STATE OF MAINE  
DEPARTMENT OF TRANSPORTATION  
16 STATE HOUSE STATION  
AUGUSTA, MAINE 04333-0016

October 20, 2022  
Subject: Southport Bridge Rehabilitation  
State WIN: 021751.01  
Location: **Southport & Boothbay Harbor  
Amendment No. 1**

Please make the following changes to the Bid Documents:

RIGHT-OF-WAY MAP  
 SHEET 1 OF 3

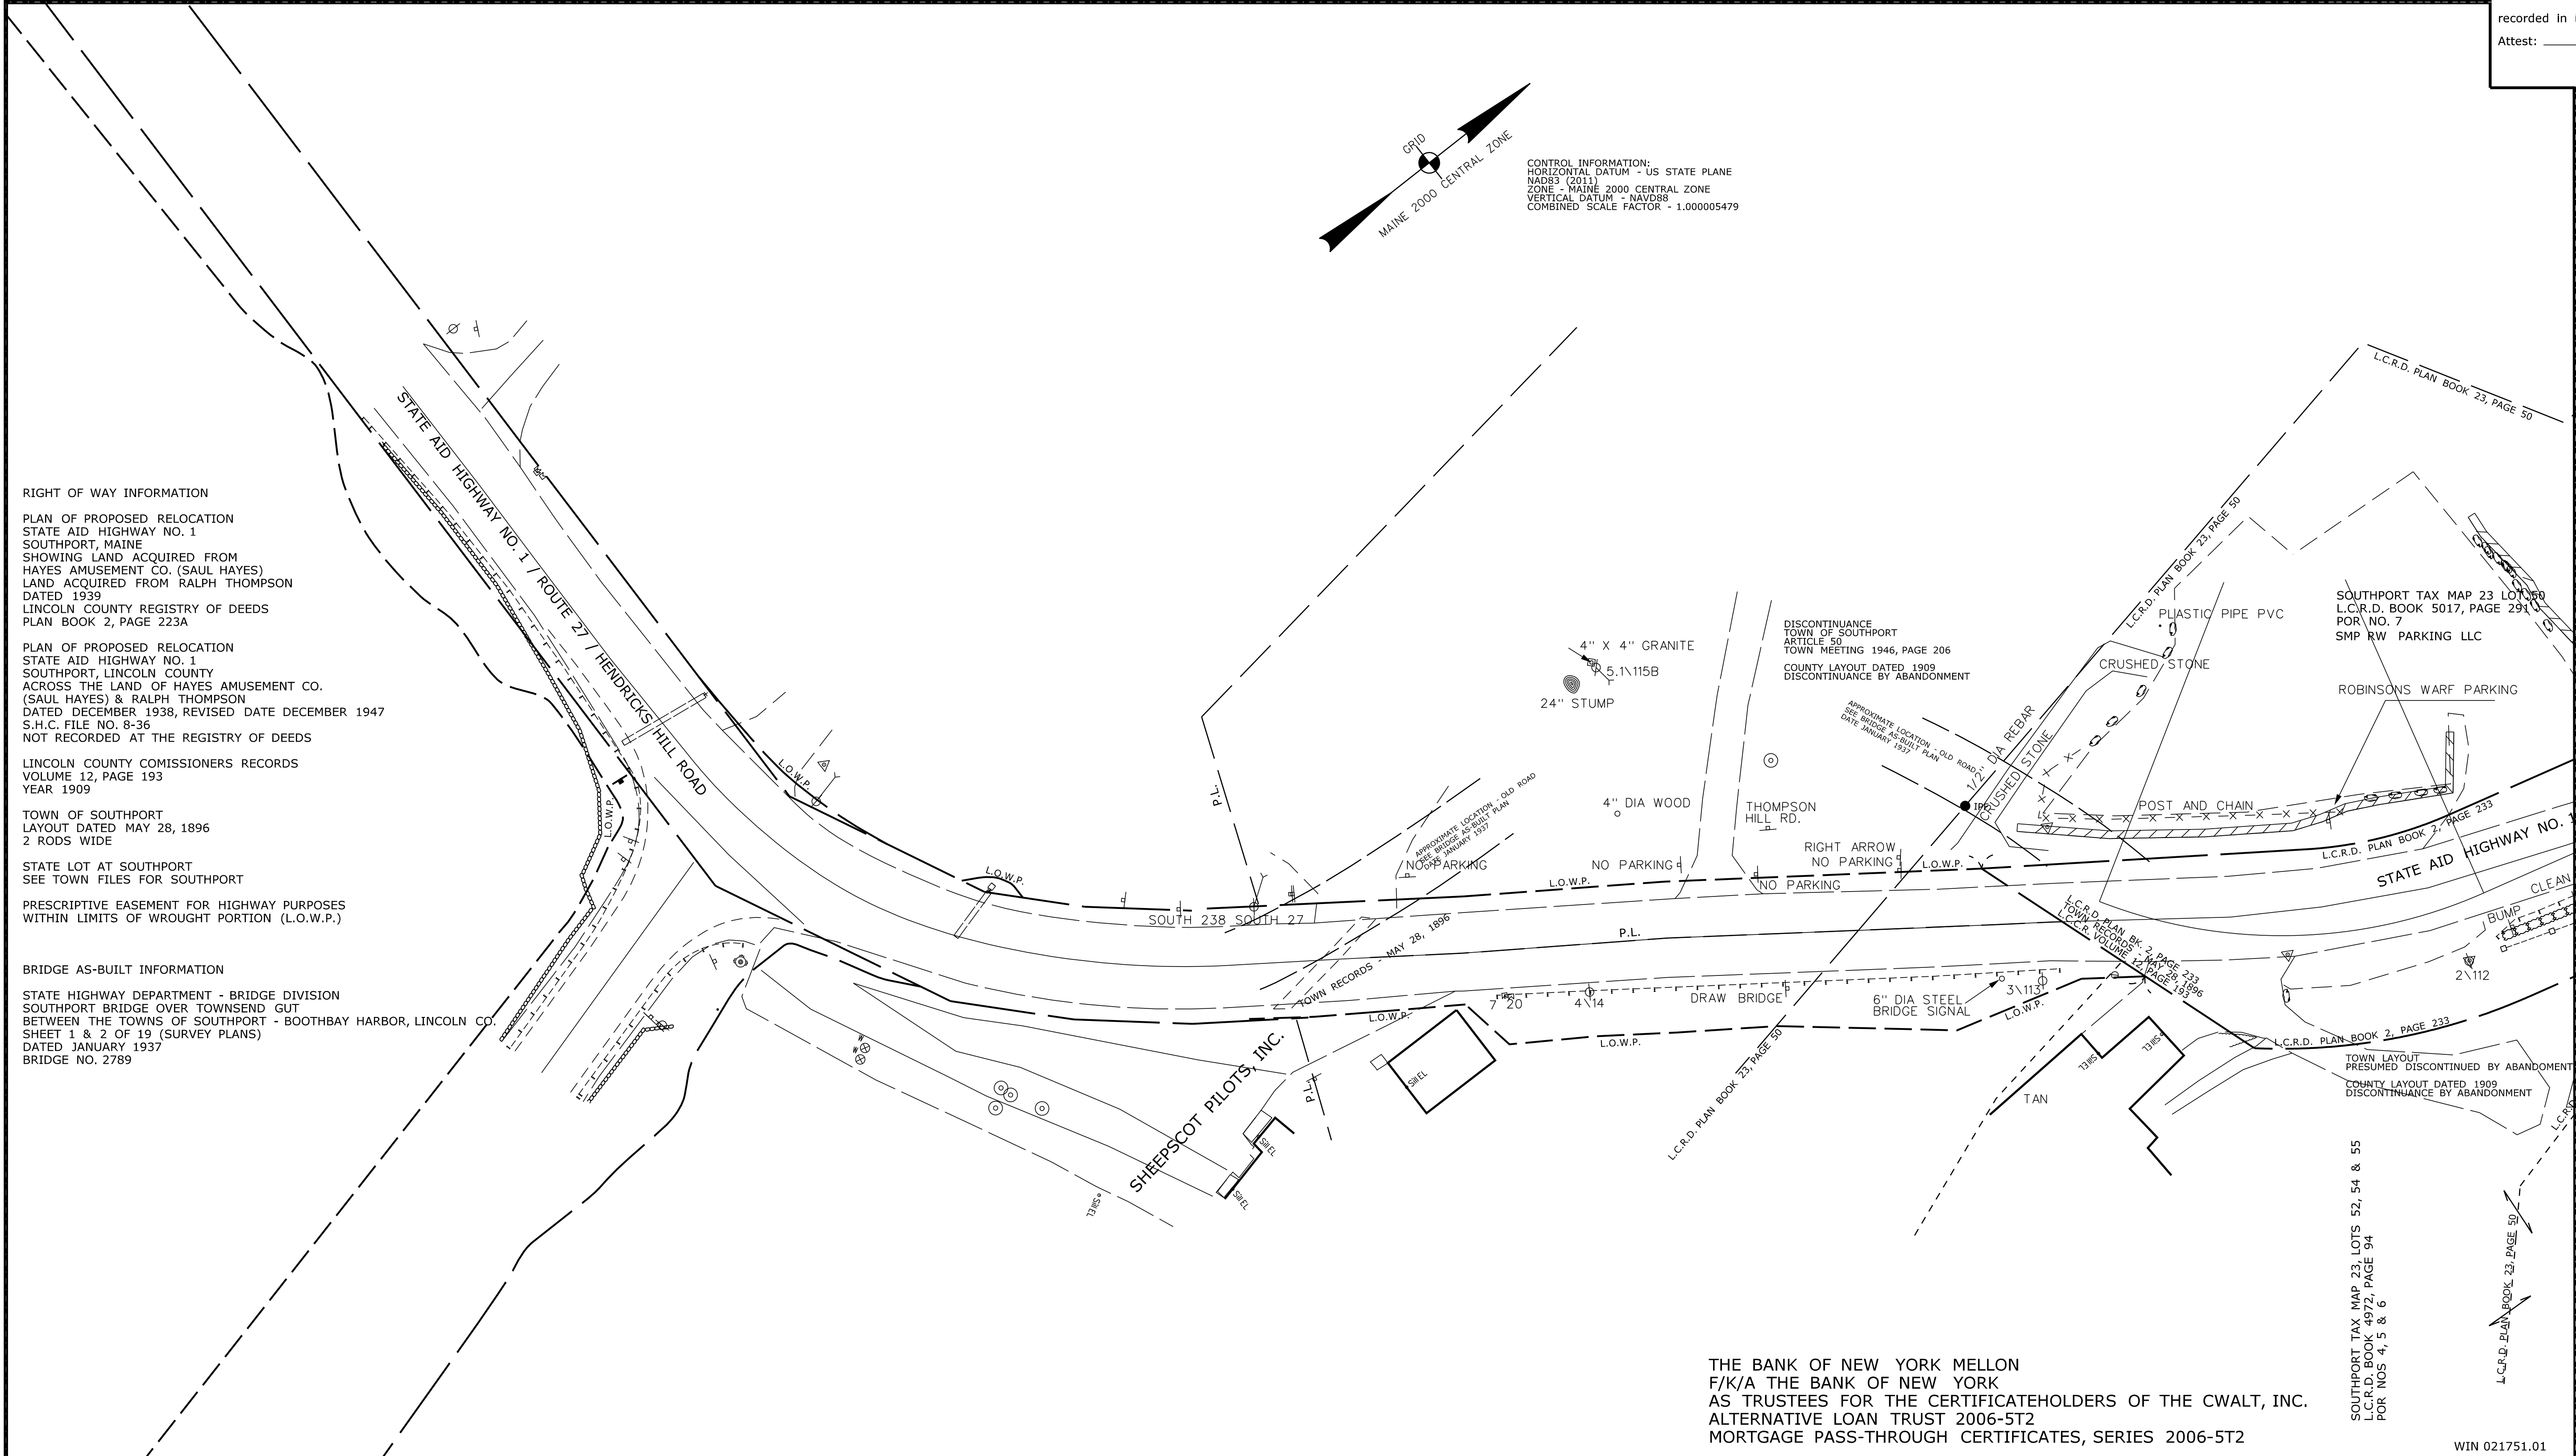
**ADD** the attached Right-of-Way plans, pages 49-51 three pages total, dated October 2022.

**Question:** Please provide a location for the Engineers Field Office. There seems to be no construction area being provided and there is no space available from local business/landowners between April and October.

**Question:** Has there been any provisions made for contractor parking, laydown, equipment staging or office locations? No temporary construction limit lines have been included on the drawings.

**Response:** MaineDOT did not acquire any additional right-of-way for this project as all work was within existing MaineDOT property and that it was constructable without additional property rights. Please reference Standard Specification Section 104.3.2 Furnishing of Other Property Rights, Licenses, and Permits. (3) Right-of-way plan sheets have been added to the plan set to show the existing right-of-way at the project location.

**Response:** MaineDOT did not acquire any additional right-of-way for this project as all work was within existing MaineDOT property and that it was constructable without additional property rights. Please reference Standard Specification Section 104.3.2 Furnishing of Other Property Rights, Licenses, and Permits. (3) Right-of-way plan sheets have been added to the plan set to show the existing right-of-way at the project location.
